Access Compliance Report

Public Rights-of-Way

| Intersection ID: 47979 | Main Street: SPRINGS_MILL_RD | Cross Street: RAFFIA_RD | Location: SW |
| ADA ID: 41C97AAAC8C9 | Ramp Type: PerpDiag | Initial Pass/Fail: Fail | Overall Compliance: No |

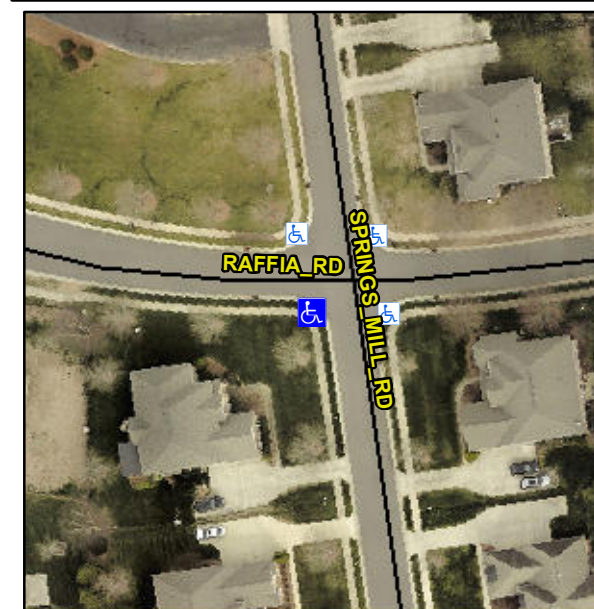
| Severity Score: 8.75 | | | |

R304.5.1

| Compliance | Description | Data | Compliance | Description | Data |
|------------|-----------------------|------|------------|-----------------------------|------|
| No | Ramp Width (in) | 46.5 | Yes | Ramp XSlope (%) | 1.6 |

Remove & Replace Curb Ramp With Two New Directional Ramps or Equivalent.
